UNITED STATES PATENT AND TRADEMARK OFFICE

APPLICATION NO.	FILING DATE	FIRST NAMED INVENTOR	ATTORNEY DOCKET NO.	CONFIRMATION NO.
10/788,957	02/27/2004	Bryan D. Simmons	31849.48	6672
46334	7590	03/17/2006	EXAMINER	
HAYNES AND BOONE, LLP 901 MAIN ST SUITE 3100 DALLAS, TX 75202				KIM, JOHN
		ART UNIT		PAPER NUMBER
		3733		
DATE MAILED: 03/17/2006

Office Action Summary	Application No.	Applicant(s)
	10/788,957	SIMMONS, BRYAN D.
Examiner	Art Unit	
John Kim	3733

DETAILED ACTION

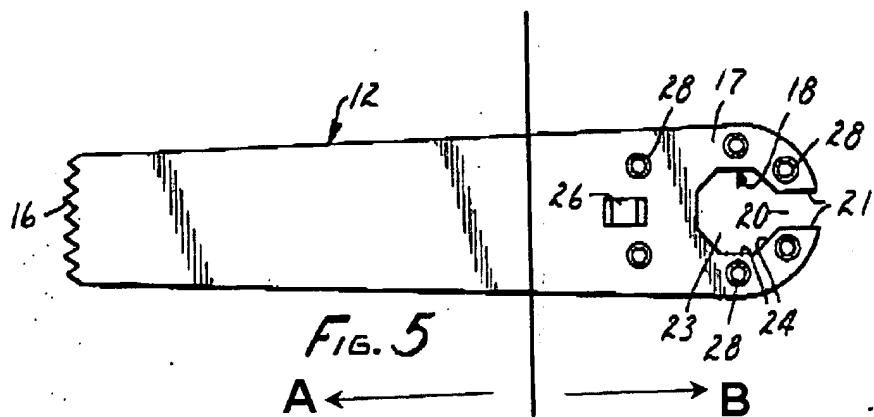
Mongeon teaches of having a surgical instrument with a motor (drive mechanism), a collet (10) with engaging members (44), and dissection tool with a tool

body (A, see modified figure below) and a hub (B, see below) with indentations (28).

Mongeon also teaches of having a housing (14) and the dissection tool is a relatively flat reciprocating saw blade (figure 1 and 5). In regards to claim 10 and 11, Mongeon teaches of having a collet assembly with a plunger (46) and a compression device (coil spring, 50) (col 3:22-57). The tool body and hub are made of metal and is a single monolith structure (claims 14 and 15).
